CITY OF YPSILANTI
Historic District Commission
Regular Meeting Agenda

Tuesday, September 13, 2016
7:00 p.m.

New Wall Sign Cabinet

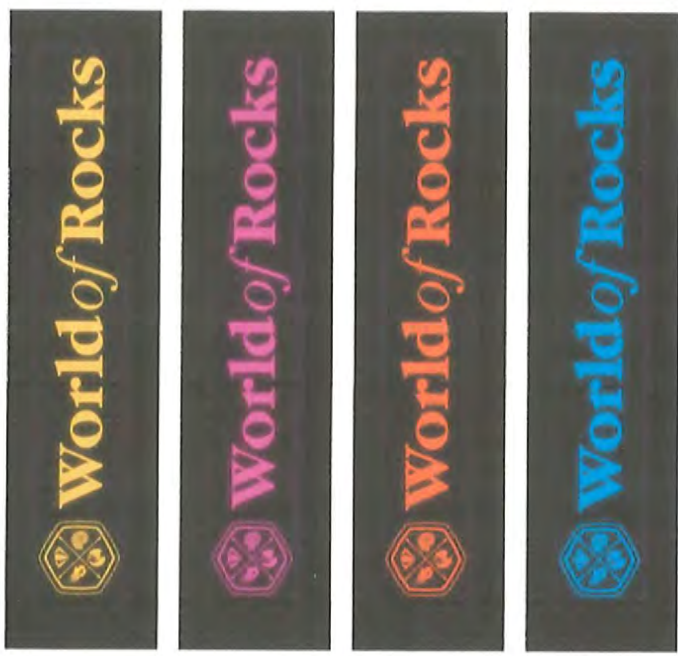
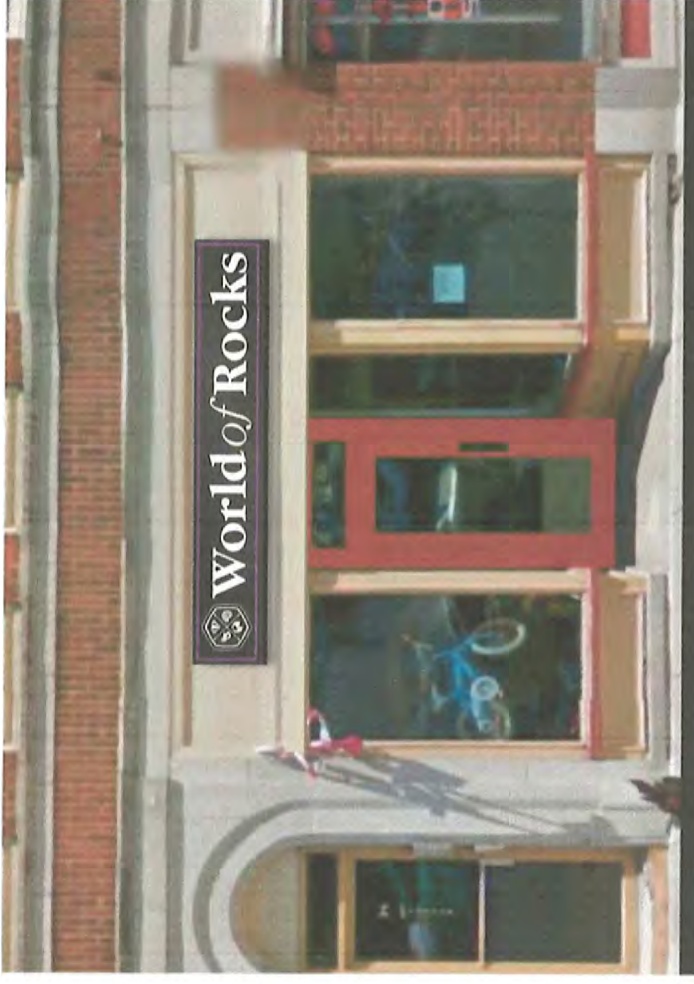
1. UPDATE: Applicant has provided new rendering with the sign in a size that meets with the sign ordinance and building department requirements. A new rendering is included in the application.
2. Originally the Building Department notified staff that the proposed wall-mounted sign had been disapproved, as it exceeded the maximum sign square footage of 14 square feet for this property.
3. The HDC may want to verify stainless steel attachment methods will be used and the lighting plan for the sign. The materials section of the application lists low voltage LED lights and the proposal states that the sign is to be back-lit.
4. The applicant is also applying for a 3'x2' sidewalk easel sign.
5. Before proceeding with work, the applicant must obtain the appropriate building department permits.

39.75 sq. ft.; meets requirements.

CLASSIC® COLLECTION

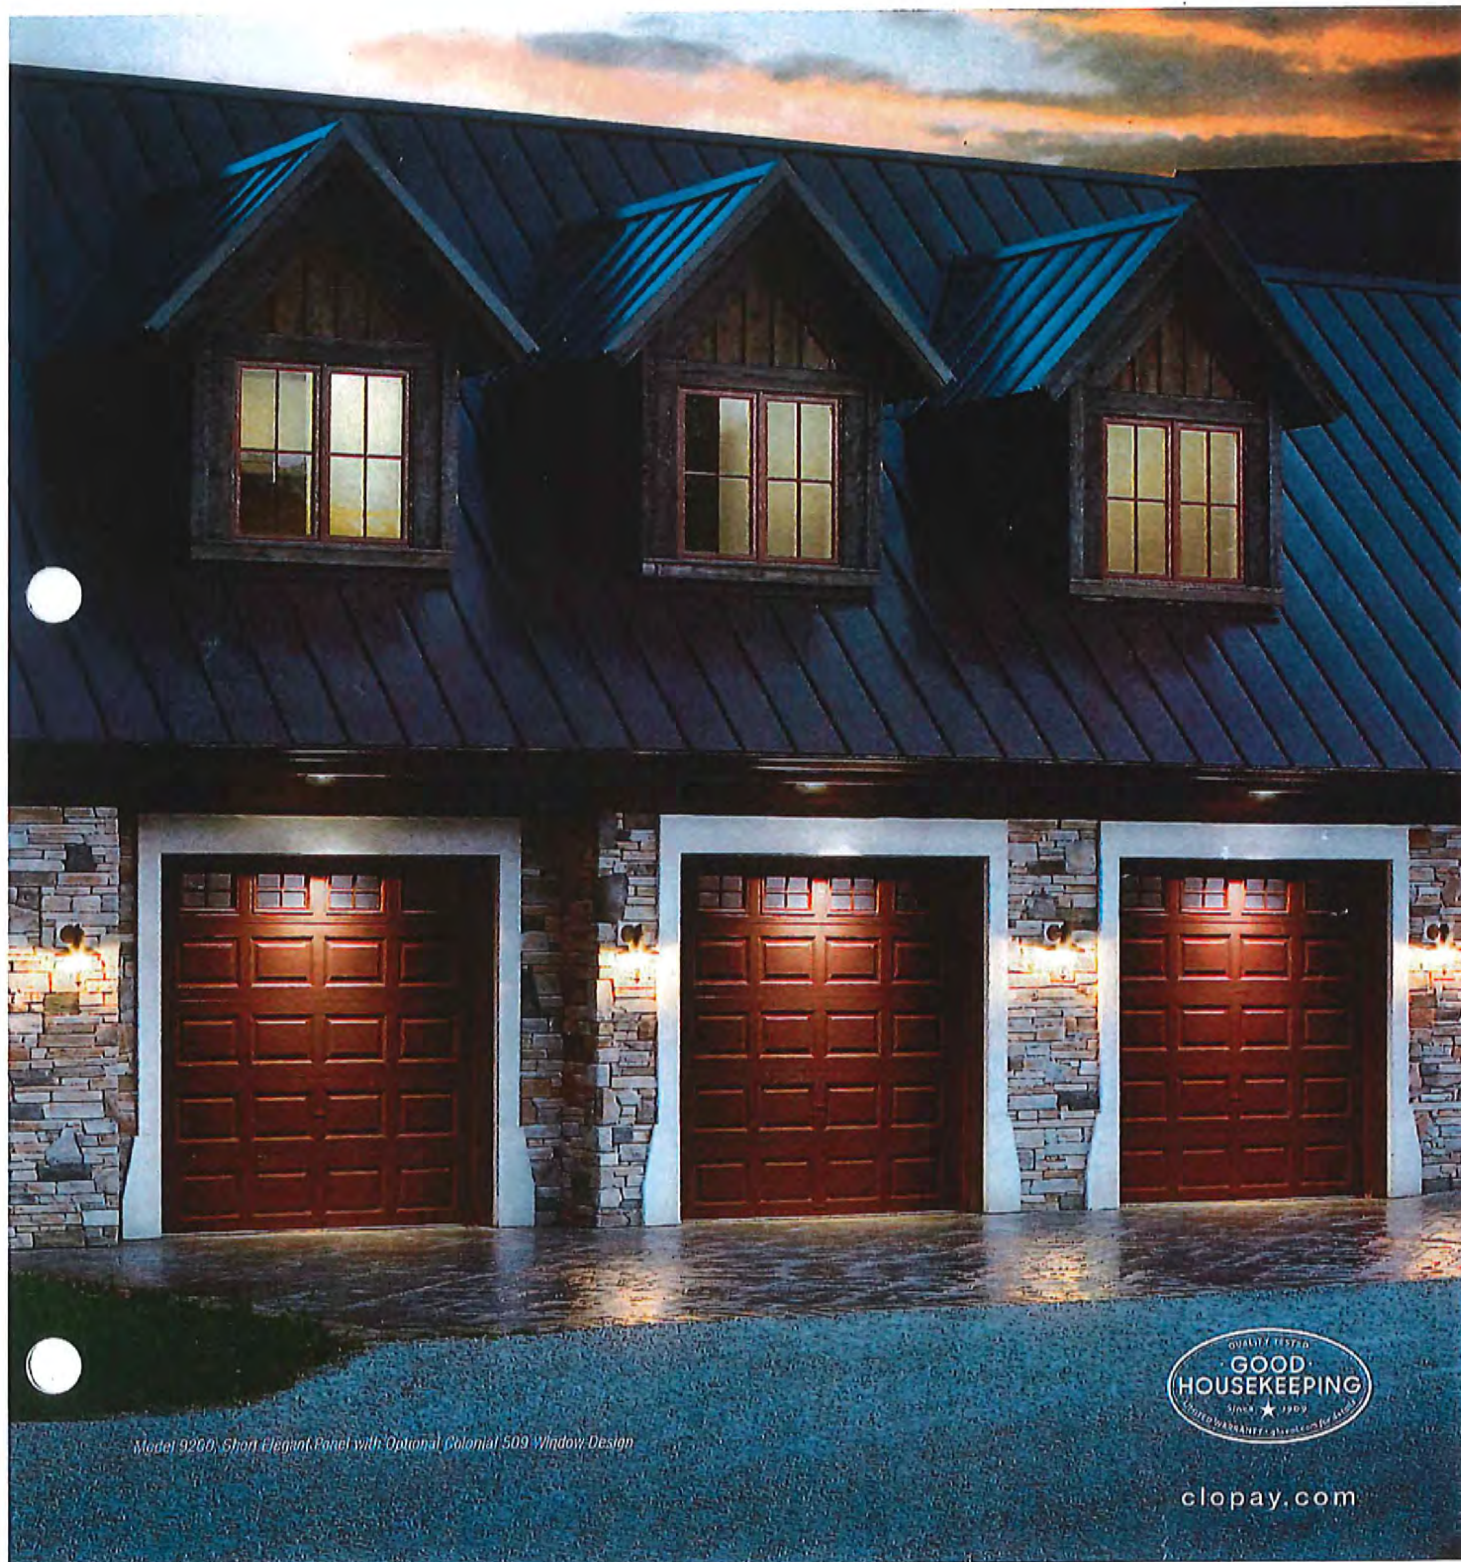
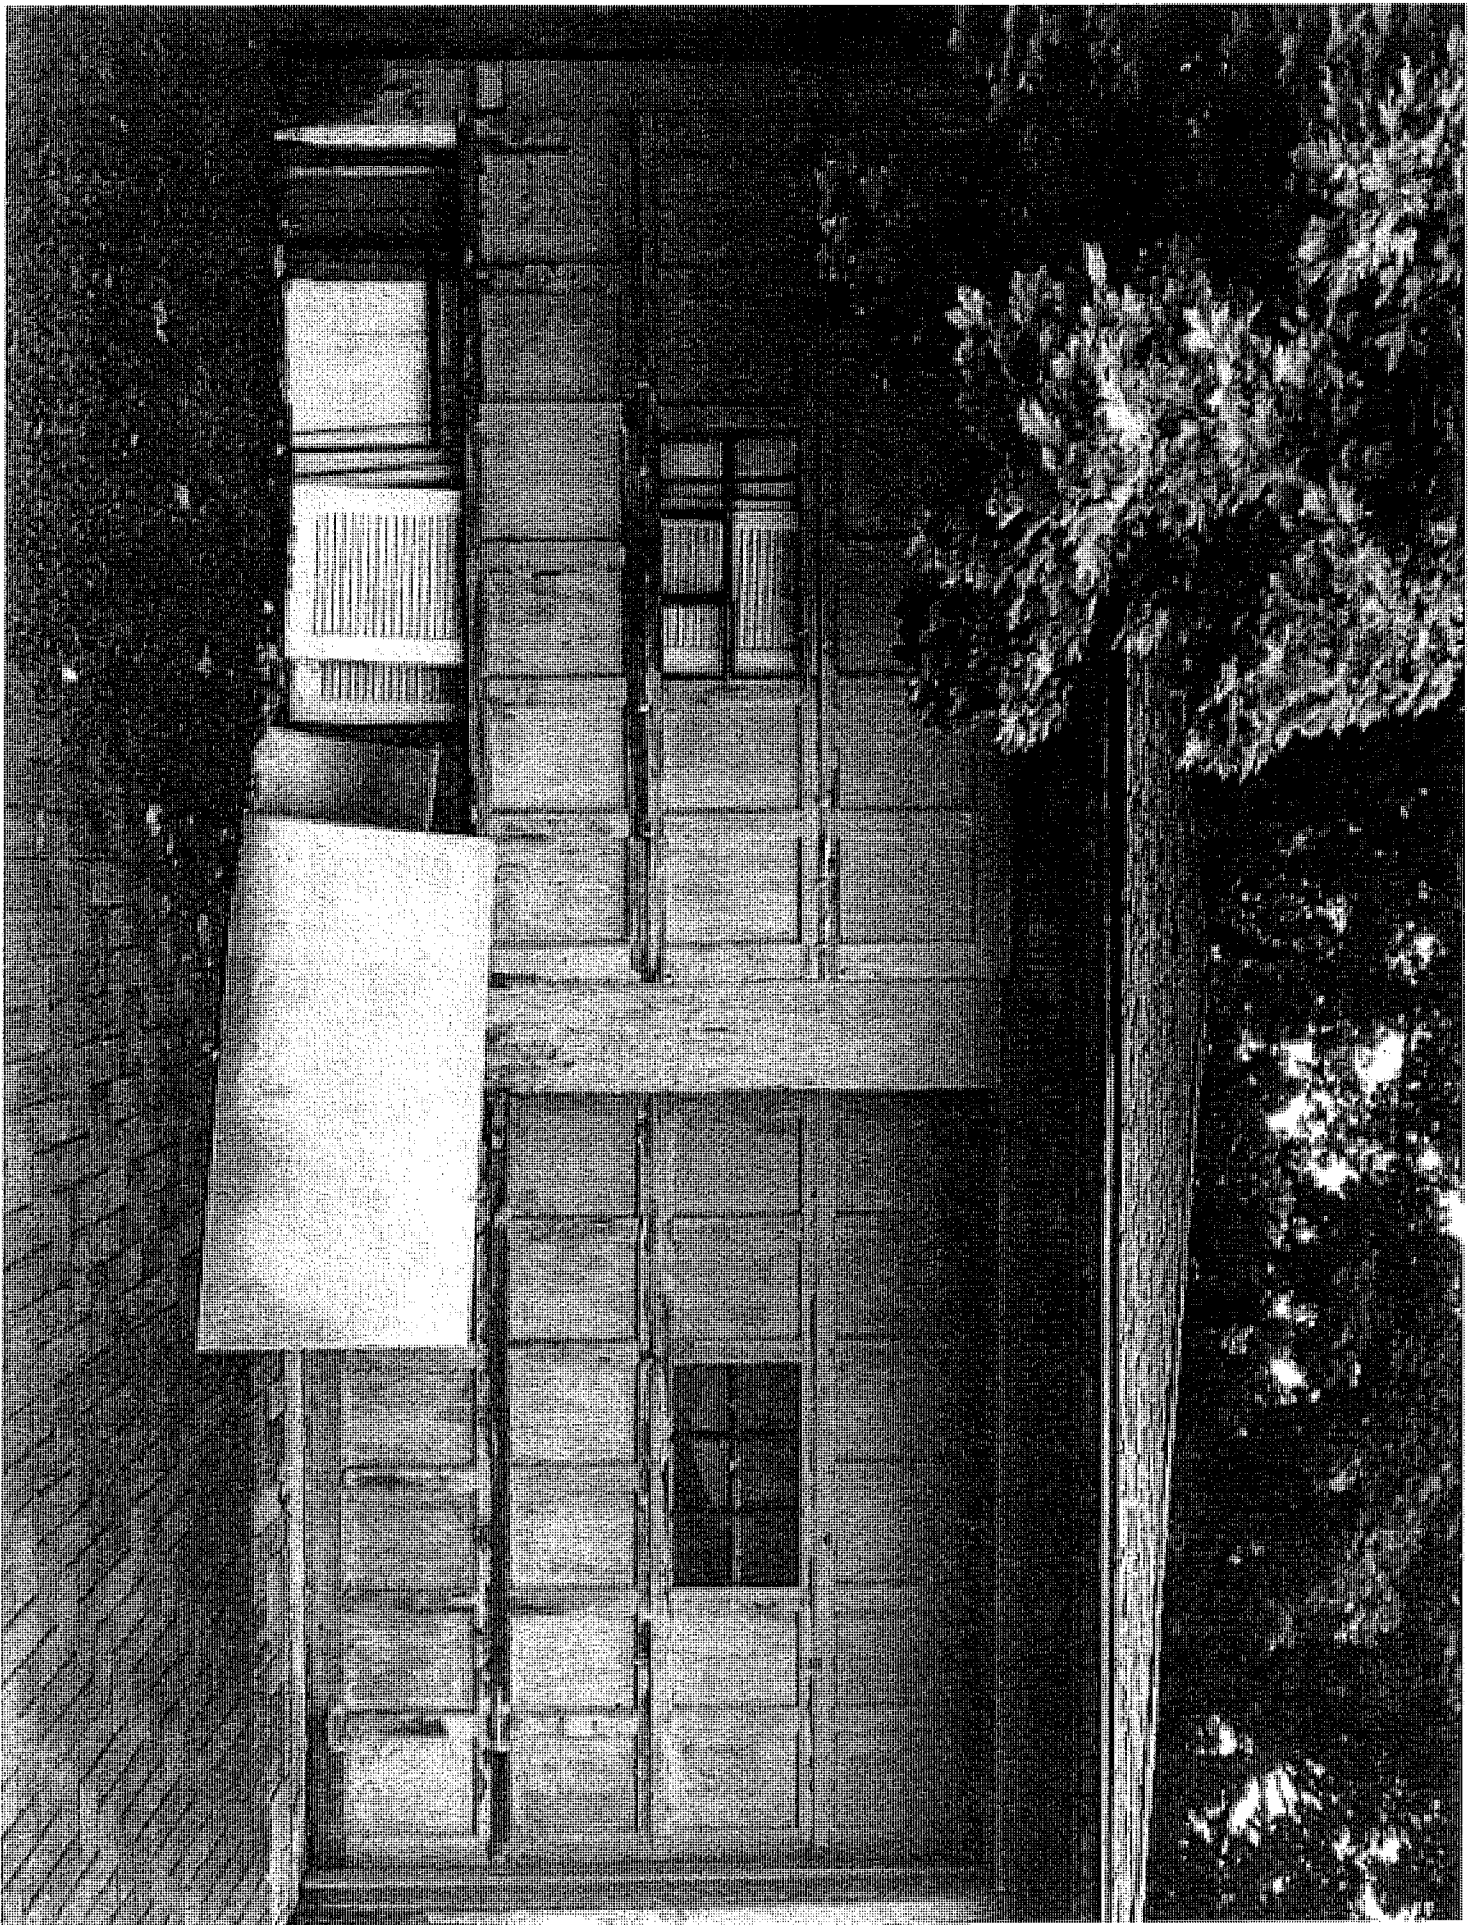
Pettit: States that the cut-sheet lists a natural embossed wood grain texture. States that this is not an option they care for.

Prebys: States that they missed the idea of a natural embossed wood grained texture. States that there is no such thing as a natural embossed wood texture on steel. Asks the Commissioners if they have a problem with the steel door. States that they approve of no windows. States that they can live with the panels. States that the color is not a problem. States that the one question they have about the grained surface.

Replace garage doors. per permit already approved with the amendment to allow woodgrain texture. Due to the fact that a smooth finish door is not ~~at~~ available to purchase new.

AAATA PROPOSED

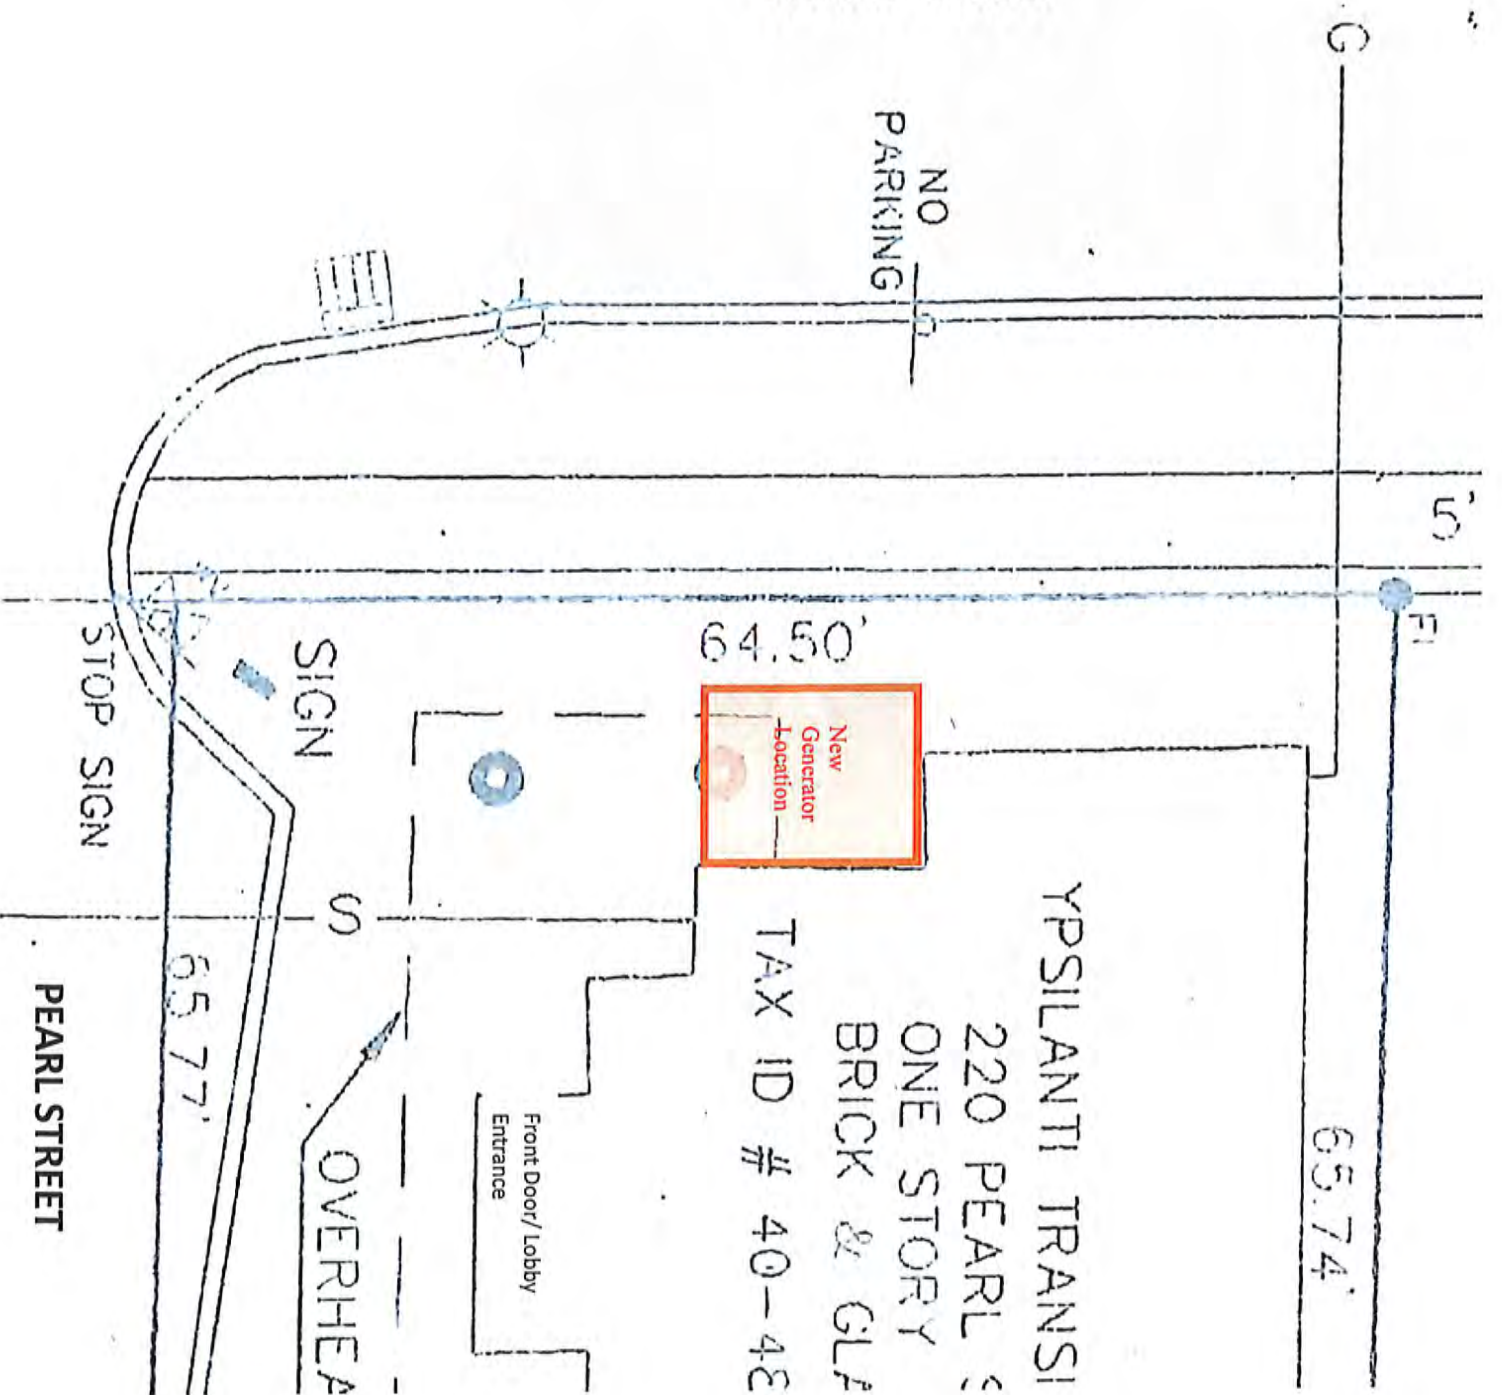
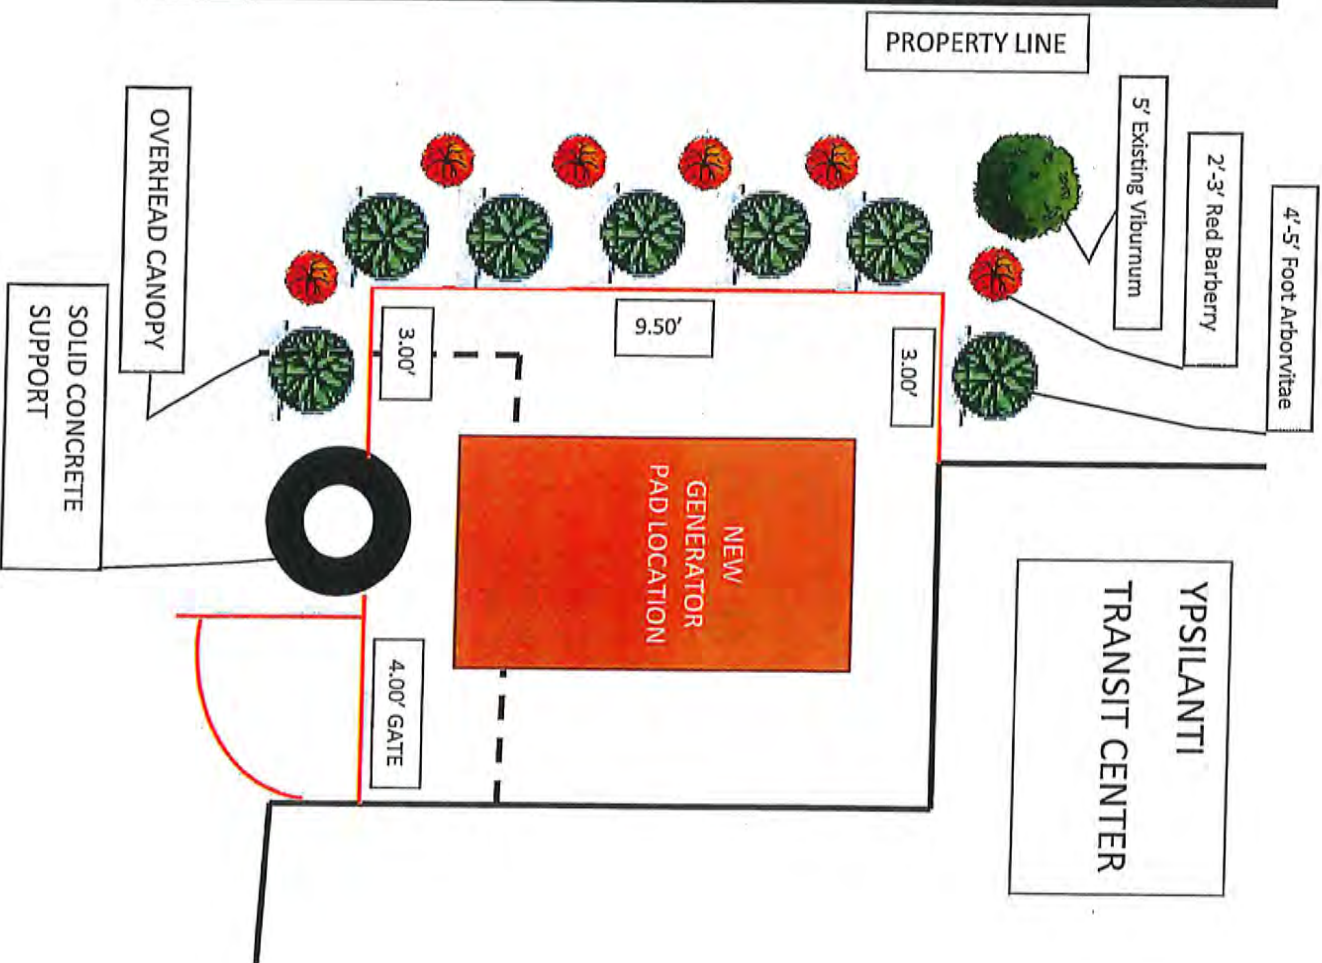
1. Applicant is installing a generator at southwest corner of the structure. Applicant was unable to locate a contractor willing to install the generator inside the finished enclosure on roof and has been working with city staff for a solution.
2. Applicant will fence in the generator and will provide a landscape hedge to attempt to disguise the generator enclosure.
3. Before proceeding with work, the applicant must seek the appropriate building department permits.

The fence would be black commercial aluminum fence. The pictures below are a concept of the style of fence, but we have not finalized the style. The landscaping would be a mix of arborvitae and barberry.

Modification

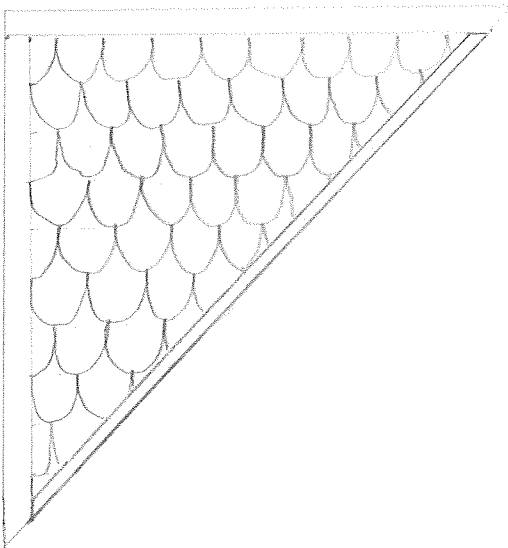
The bottom 2 ½ inches of scalloping will be cut away and a 1x3 piece of lumber placed along the roof edge to provide a cleaner edge that will insure a better seal between the roof and the edge of the dormer, as well as with the vertical support of the dormer on the left (which is where multiple leaks have occurred, as the recessed scallops create a pooling spot).

The north face of the dormer is clapboarding. No leaking has been detected there, but we propose doing a similar modification on that face for reasons of symmetry.
